March 5, 2025

## SANTA FE COUNTY IFB NO. 2025-0194-PW/DK ROMERO PARK WATERLINE PROJECT ADDENDUM NO. 1

Figure:: Tie in location provided by CofSF

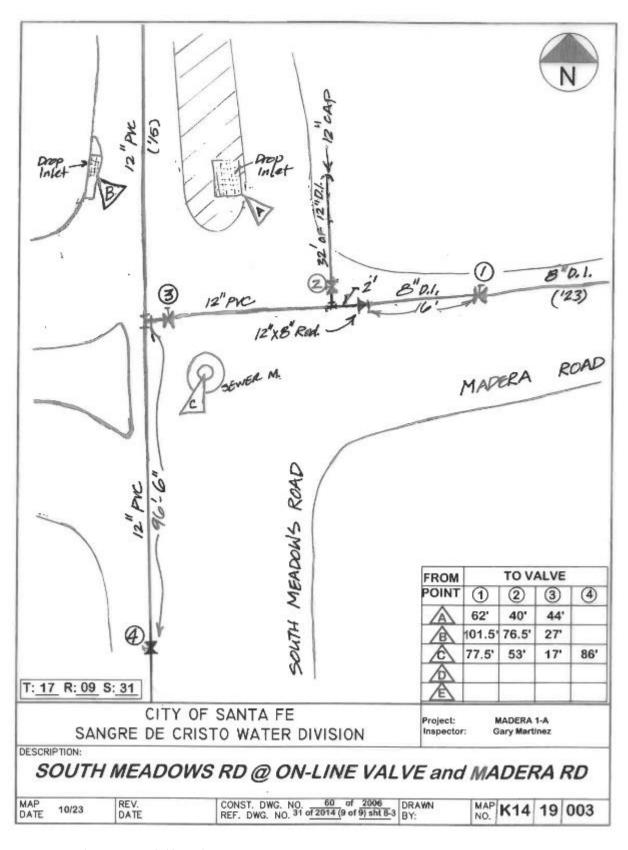
Question No. 4: During our site visit we see that a new turn out has been constructed at approximately STA 10+40. Will this interfere with the new 12" WL Tie-in?

Answer No. 4: The turnout should not affect the tie in location. The valve may be in the asphalt, but the tie in location is supposed to be outside of the asphalt. See attached image provided by the City of Santa Fe.
